**ADDENDUM NO. 3**

November 1, 2022

**RE: Component 4 & 6: Liquid Transloading Facility - Civil, Structural and Fire Suppression Site Work at Facility One**

MIDWEST TERMINALS FACILITY 1 ELECTRICAL			
DATE	10/24/2022	ADDRESS	3518 ST. LAWRENCE DRIVE
DRN	GMT	CDD	KEM
APVD	K. MILLER		SCALE
TITLE	<b>PARTIAL SITE PLAN: FOAM HOUSE AREA</b>		MT-101-3005

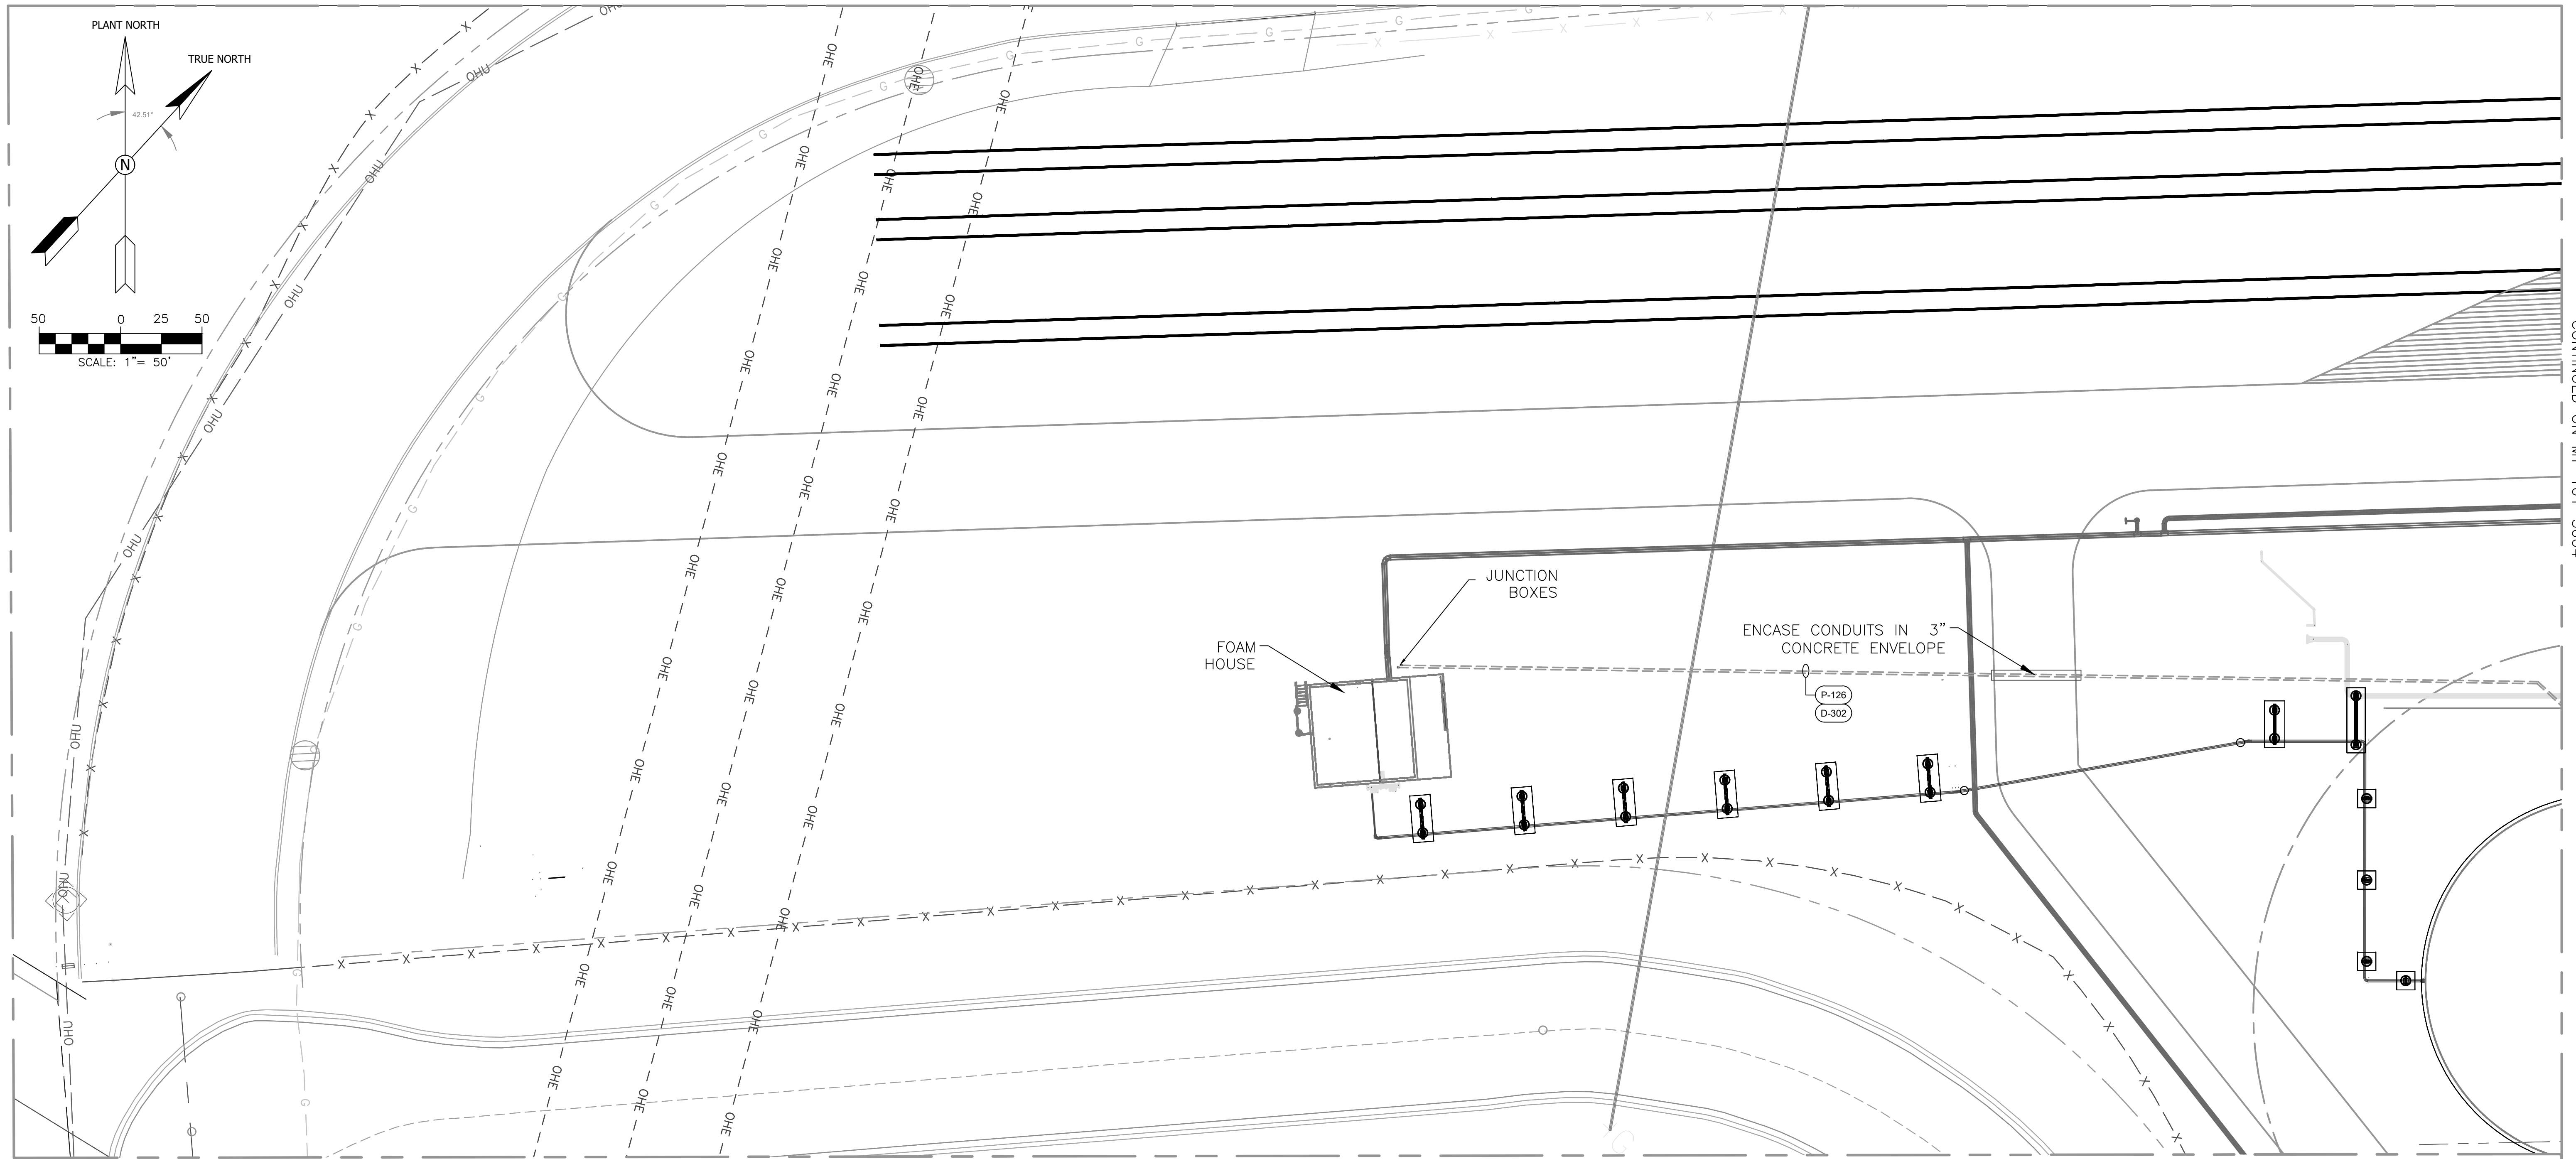
2. Drawing MT-101-3005 (SEE ATTACHED)
  - Partial Site Plan: Foam House Area – Revised

17. **Question:** Please clarify the scope of work between drawings for the Foam House on JDRM Drawing ED2 and MT-101-3005. Underground layout with J-boxes is different between the two drawings. Does the scope stop at the J-boxes?

**Answer:** Please utilize MT-101-3005 updated 10/24/22 for clarification of the underground conduit path from the cable tray to the Foam Building and disregard the routing on JDRM drawing E-2. There will be no J-boxes near the cable tray.

For specification of the J-boxes and installation from the boxes into the Foam Building, utilize JDRM E-2.

Please note that the power conduit should be a 3" (P-126) and the Communications Conduit should be 2" (D-302) and should be sized similarly from the J-boxes to the Foam Building.
